AIRWORTHINESS ADVICE NOTICE

GFA AN 77

ITEM 1: Schweizer banner towing/gliding towing hooks.

SUBJECT: SCHWEIZER SAILPLANE TOW RELEASE, PROPER ATTACHMENT OF TOW LINE,
INSPECTION, MAINTENANCE PROCEDURES AND REWORK OF TOW HOOK, RELEASE
ASSEMBLY AND RELEASE DAMPER.

FIGURE 1

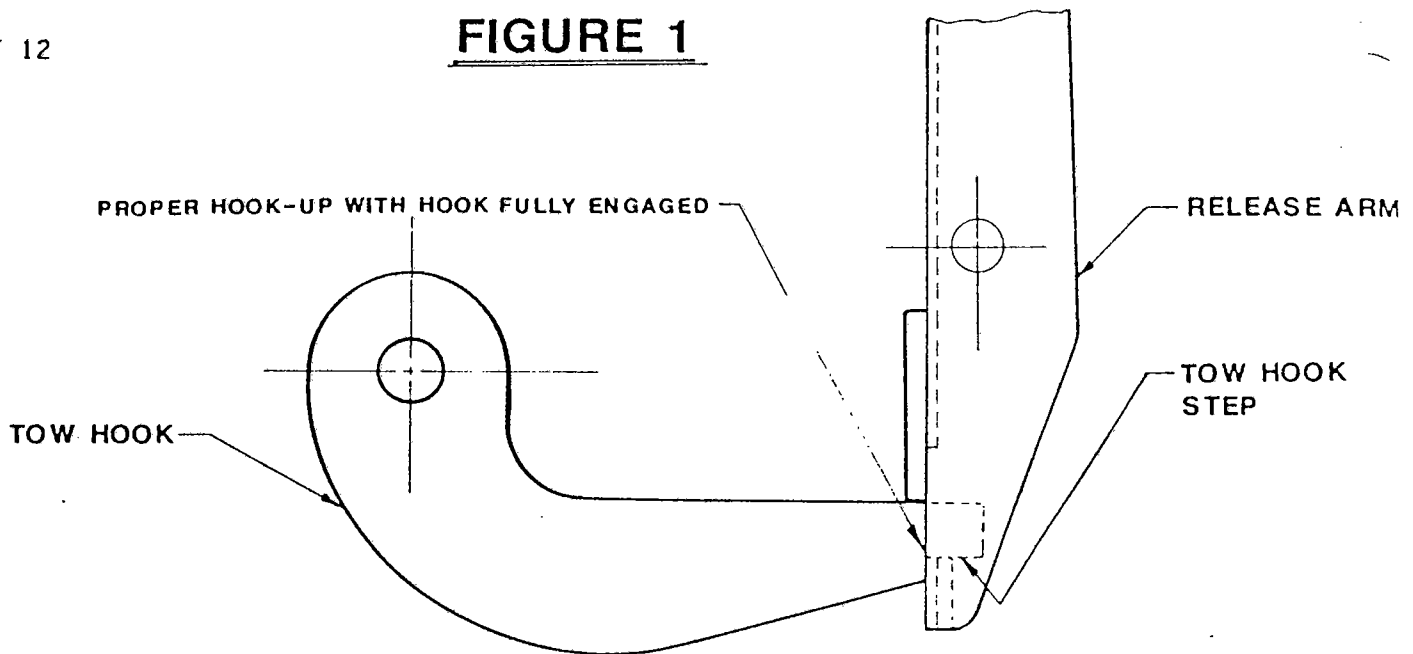
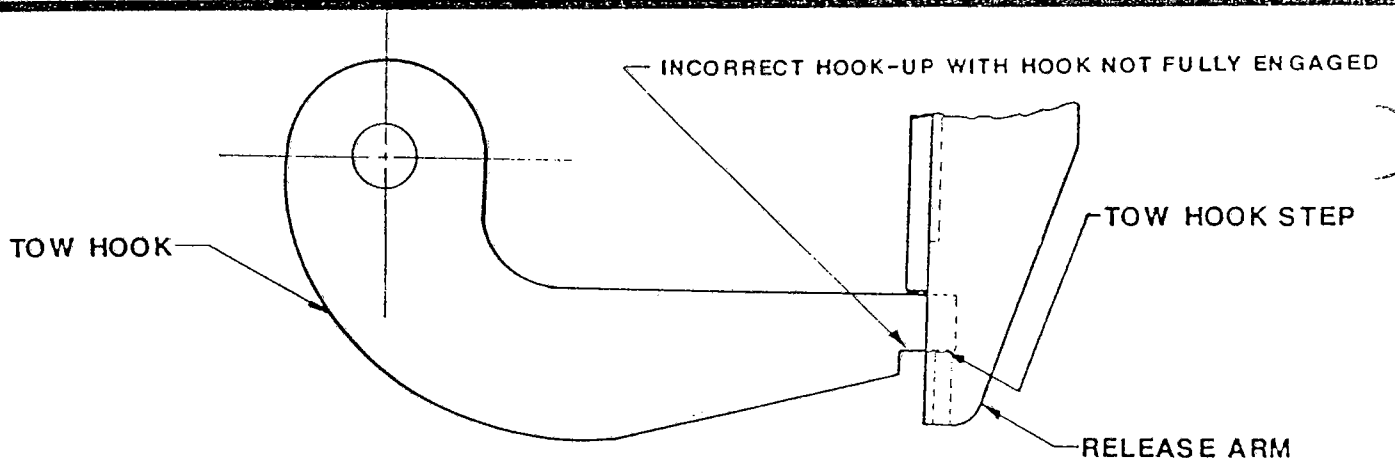
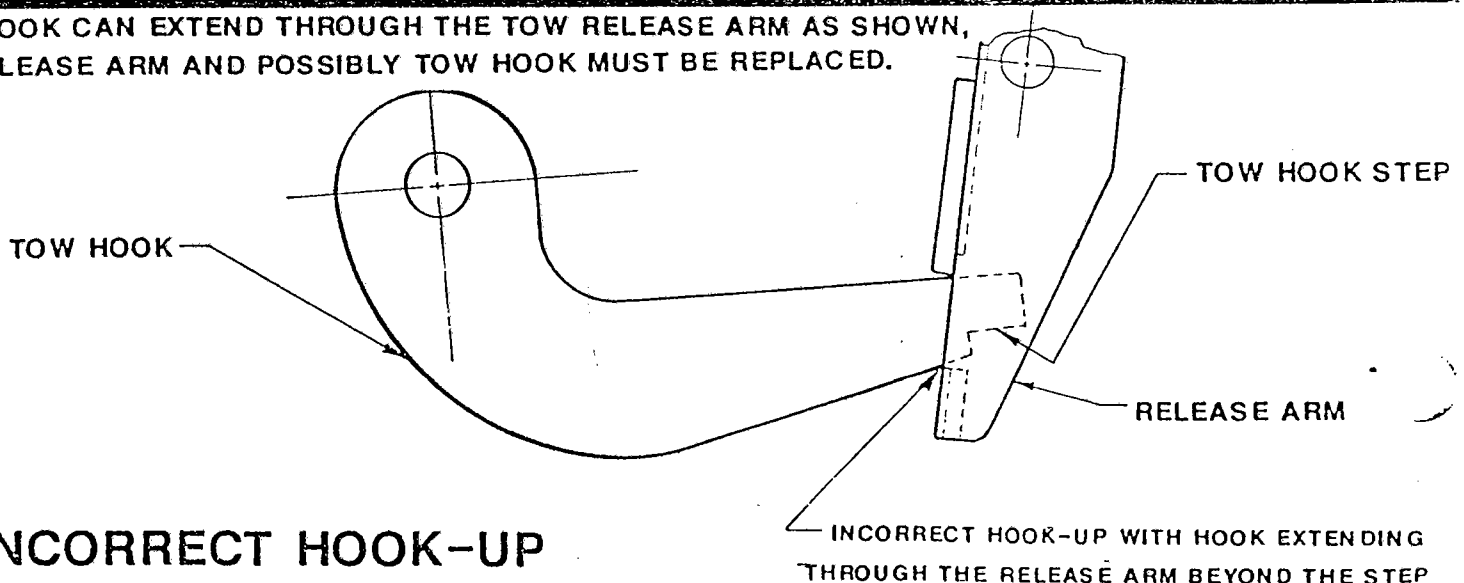
Figure 1 shows the positions for the tow hook and release arm when correctly hooked-up. Note that the step of the tow hook should be tight against the release arm assembly. The tow hook step must fully engage the release arm to allow the release assembly to work properly. The tow hook must not be allowed to extend through the release arm beyond the step on the hook since this creates a condition which defeats the design of the release and increases the possibility of an inadvertent release.

Tow hook must engage release arm in accordance with Figure 1A & Figure 4. If hook is able to pass through release arm beyond step as shown in Figure 1C, release arm and/or hook must be reworked with slug or replaced.

If tow hook fails to engage completely as shown in Figure 1B, check release control rigging. Shortening the rubber bumper stop between the release knob and instrument panel will allow the release assembly to close further.

HOOK CAN EXTEND THROUGH THE TOW RELEASE ARM AS SHOWN, RELEASE ARM AND POSSIBLY TOW HOOK MUST BE REPLACED.

FIGURE 2. TOW HOOK INSPECTION AND REWORK (SHEET 1 OF 2)

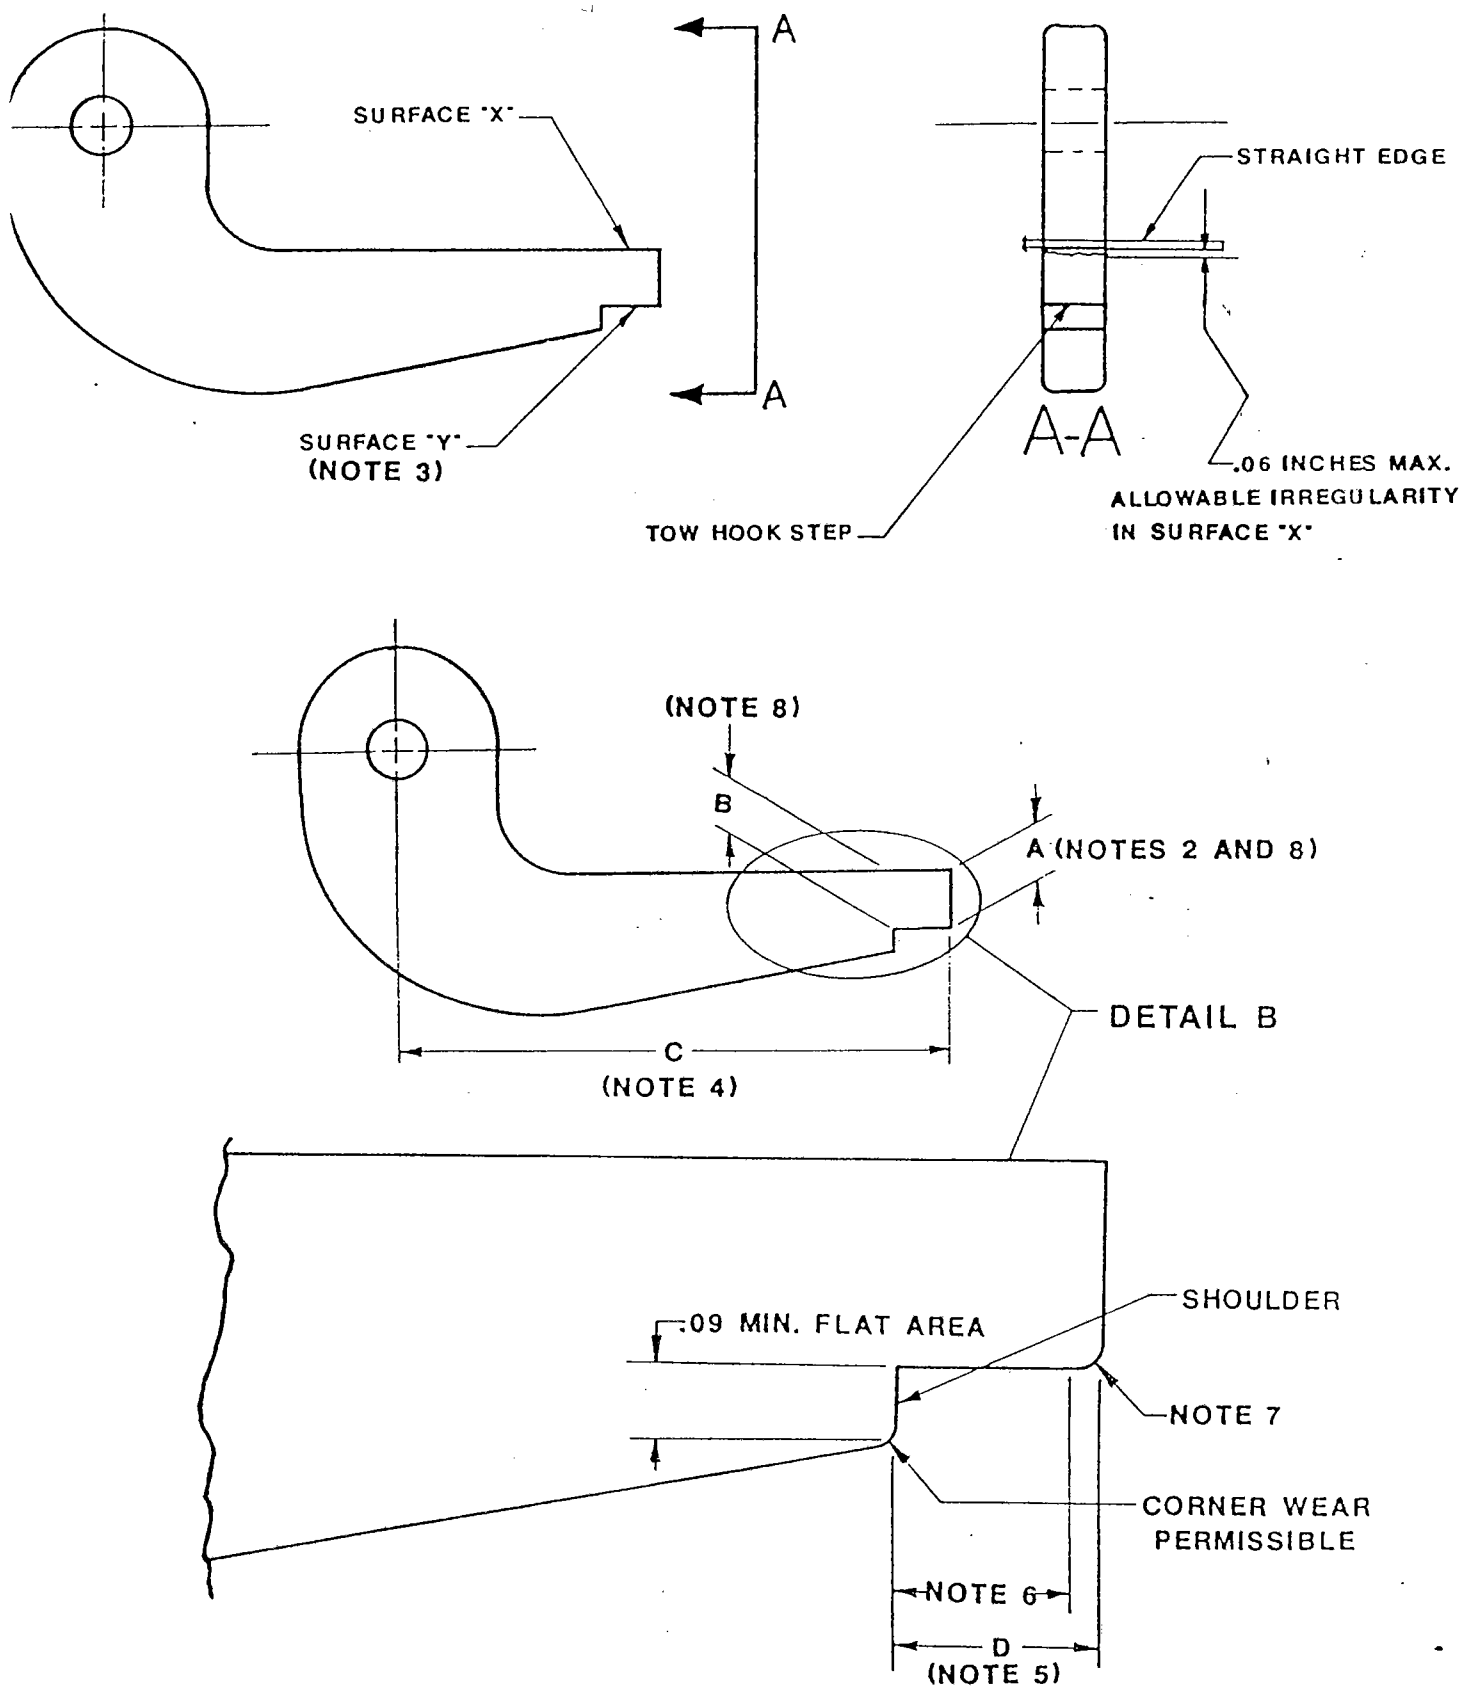
- B. Wear of the tow hook step will cause improper engagement of the hook and release. The tow hook must be inspected in accordance with Figure 2. Any tow hook which does not meet the minimum specified dimensions, after inspection and/or rework, as listed in Figure 2 must be replaced.

1. IF WEAR OCCURS ON SURFACE "Y" IT MUST BE POLISHED FLAT WITHIN TOLERANCES PROVIDED IN FIGURE 2 (SHEET 1). IF THE HOOK CANNOT MEET THESE REQUIRED DIMENSIONS IT MUST BE REPLACED. UNDER NO CONDITIONS SHOULD SURFACE "X" BE POLISHED OR MACHINED TO CHANGE ITS ANGLE.

2. DIMENSION "A" ON 10232A-1 HOOK SHALL BE .21 INCHES MIN. & .28 INCHES MAX. DIMENSION "A" ON 1A-218-1A, 1B-221-1, 1B-221-3, & R-200-9A HOOKS SHALL BE .25 INCHES MIN. & .31 INCHES MAX.

3. SURFACE "Y" MUST REMAIN FLAT, SMOOTH, AND WITHIN TOLERANCES SHOWN ON SHEET 1. (SEE ILLUSTRATION.)
4. DIMENSION "C" ON 10232A-1 HOOK SHALL BE $2.06 \pm .03$ INCHES. DIMENSION "C" ON 1A-218-1A, 1B-221-1, 1B-221-3, & R-200-9A SHALL BE $3.00 \pm .03$ INCHES.

5. DIMENSION "D" SHALL BE $.31 \pm .03$ INCHES.
6. HOOK MUST REMAIN FLAT IN THIS AREA FOR A MIN. OF .21 INCHES FROM SHOULDER OF HOOK.
7. WEAR OUTSIDE OF THE .21 MIN. FLAT AREA IS PERMISSIBLE.

8. DIMENSION "B" MUST BE EQUAL TO DIMENSION "A", OR LESS THAN DIMENSION "A" BY NO MORE THAN .015 INCHES AND CANNOT BE GREATER THAN DIMENSION "A".

FIGURE 3

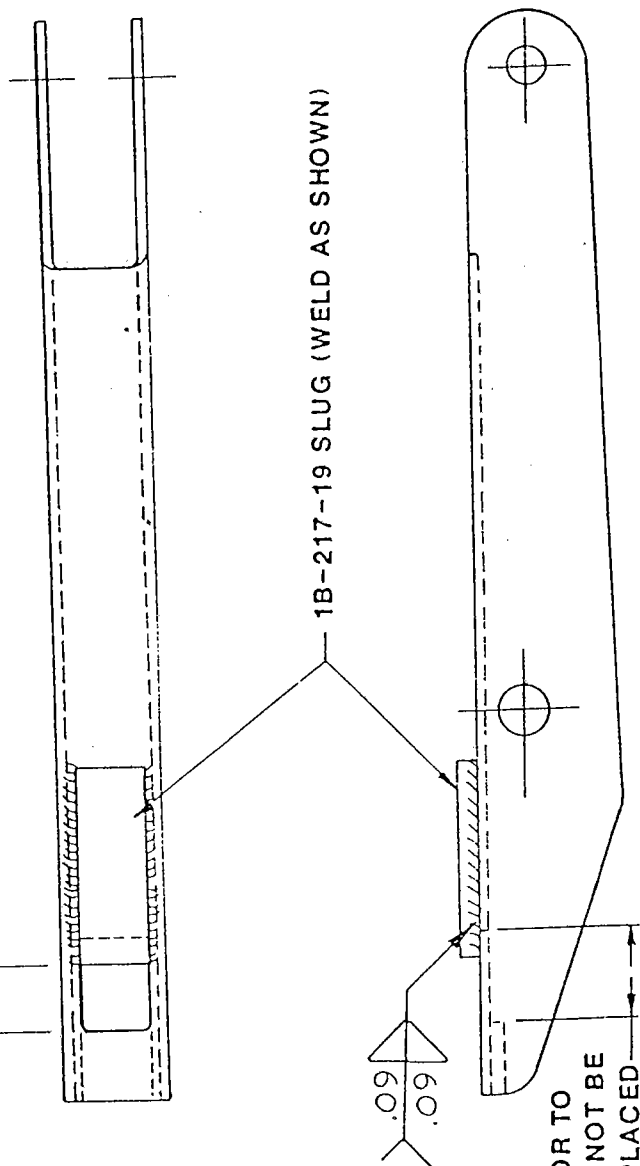
- C. All tow release arms must be reworked in accordance with Figure 3 or replaced with a new superseding Schweizer release arm as listed in Table 1. If the release arm wear exceeds the dimensions given in Figure 3, rework is NOT allowed and replacement is MANDATORY.
- D. Perform complete inspection in accordance with Item 4 of this bulletin.

IF THIS DIMENSION IS
.66 INCHES OR GREATER PRIOR TO
REWORK THE RELEASE MUST NOT BE
REWORKED AND MUST BE REPLACED

NOTICE...ALL TOW RELEASE ARMS MUST BE REWORKED AS SHOWN
ABOVE OR REPLACED WITH THE PROPER SUPERSEDING
UNIT PER TABLE 1

.35 ± .03 INCHES ON AIRCRAFT EQUIPPED WITH 10232A-1 TOW HOOK
.40 ± .03 INCHES ON AIRCRAFT EQUIPPED WITH 1A-218-1A, 1B-221-1,
1B-221-3, OR R-200-9A TOW HOOKS

FIGURE 4

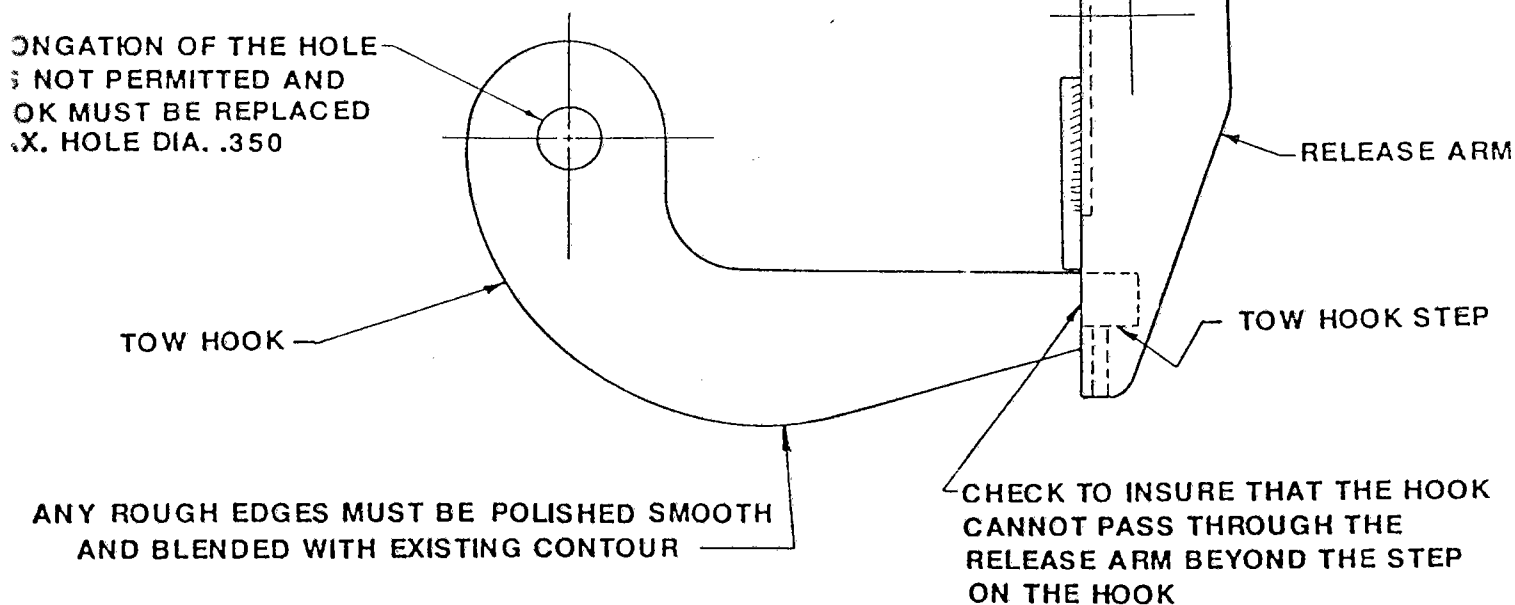
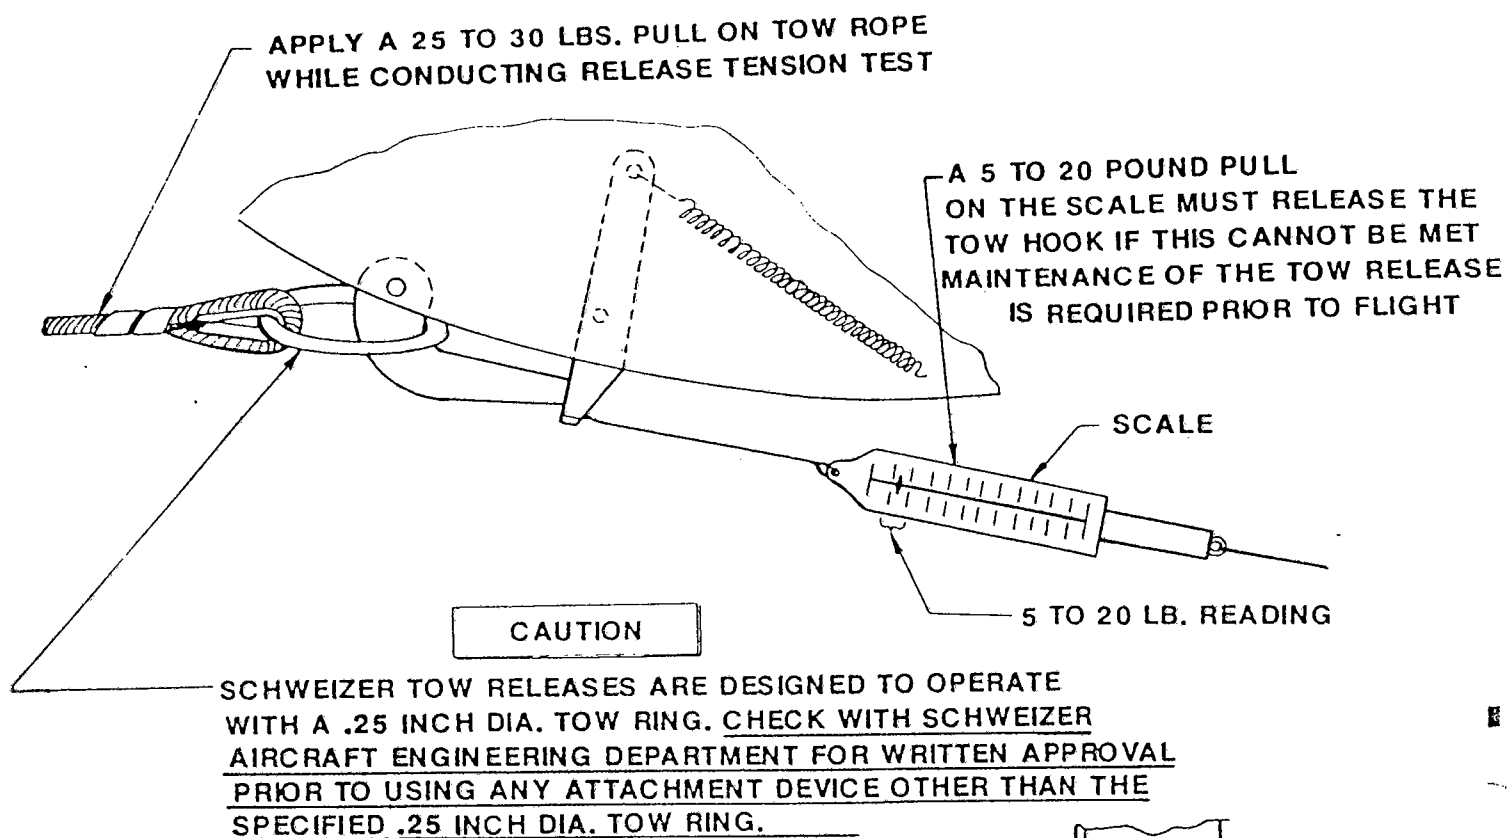
Part 4: Conduct inspection of tow release at 100 hour intervals in accordance with Table 2 and Figure 4 of this bulletin.

IF TOW HOOK CAN EXTEND THROUGH THE TOW RELEASE ARM, RELEASE ARM AND POSSIBLY TOW HOOK MUST BE REPLACED.

Schweitzer Type Hook (MODIFIED), BGA MOD T1185.

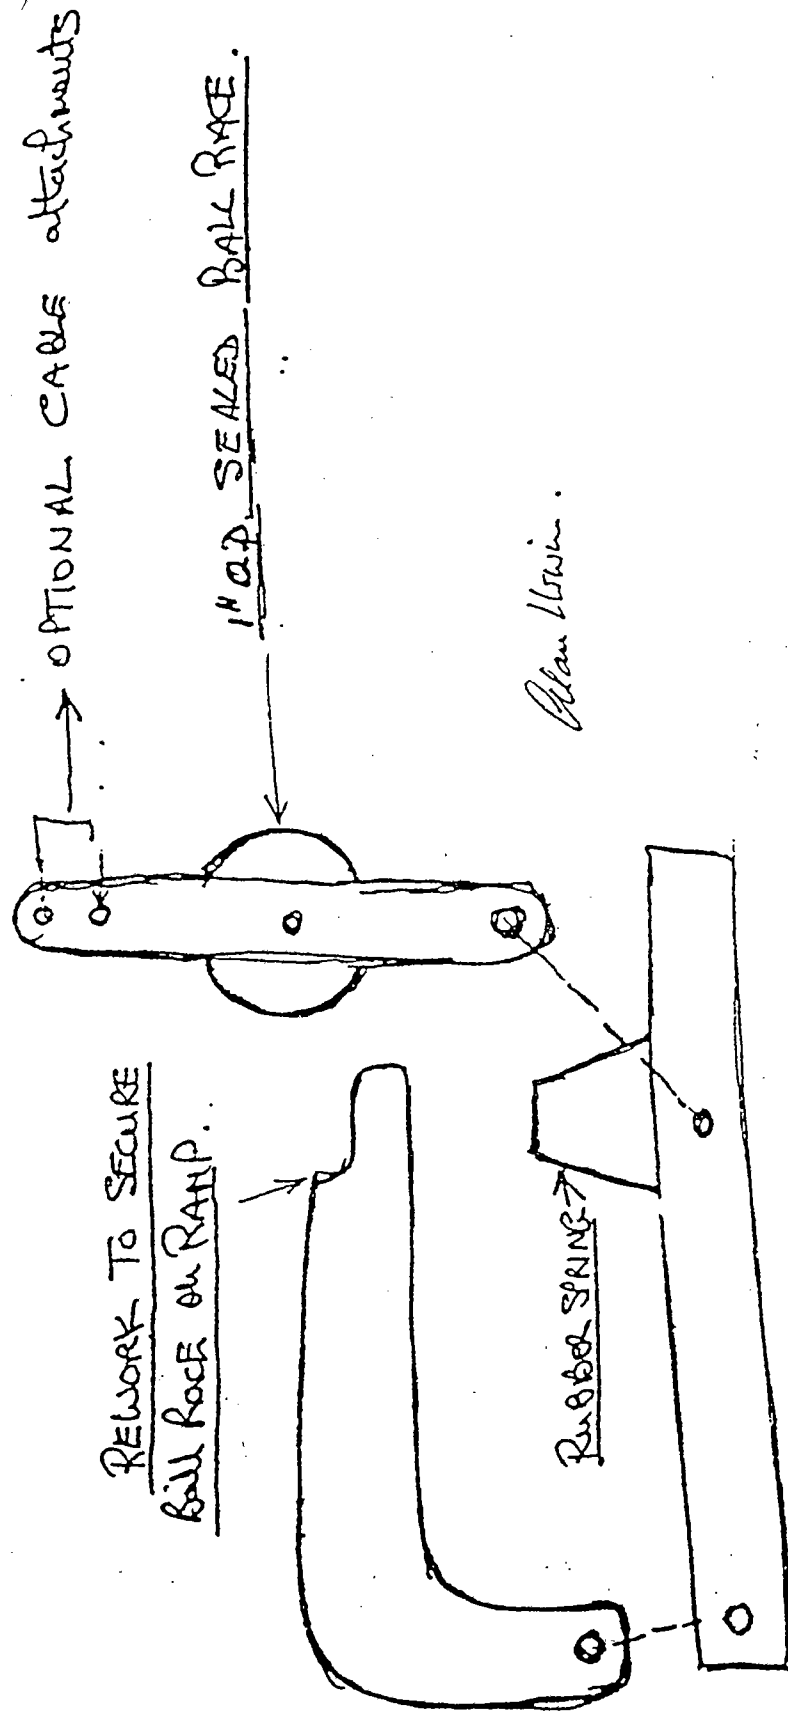
To improve the operation of Schweitzer Type Tow Hooks, (normally used for both Banner and Glider Towing), when used for Glider Towing, by replacing the roller by 1" O.D. sealed ball race.

The pull-off loads to release the tow cable under tension are reduced from 95lbs (approx) to 25lbs (approx).

with 1" O.D. Sealed Ball Race - to reduce the Release load. (By 75% under tension approx).
